No. 96-15

Required ECM Replacement

72801

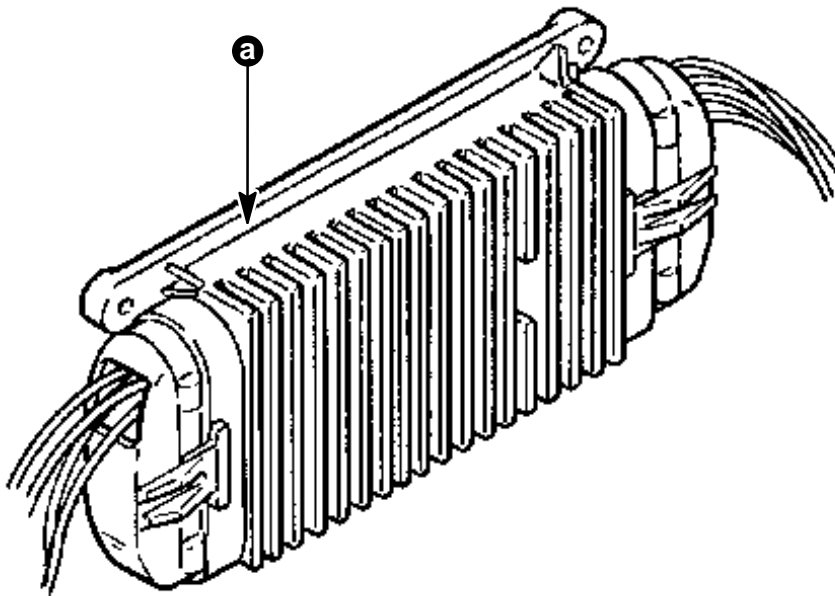
The calibration programmed into the production ECM will not sound the Audio Warning Alarm until 311 °F (155 °C). This temperature is too high and will not warn the boat operator early enough if the engine starts to overheat.

- ▲ Look at the number on the white tag on the ECM. Refer to "A" or "B" under drawing.

- ▲ a - "A" Engines With Number 9629: DO NOT Change. Any Other Number, Change ECM.
"B" Engines With Number 9138: DO NOT Change. Any Other Number, Change ECM.

▲ "A" Engines: Order (1) 807210T 5 Engine Control Module (ECM).

"B" Engines: Order (1) 807268T 3 Engine Control Module (ECM).
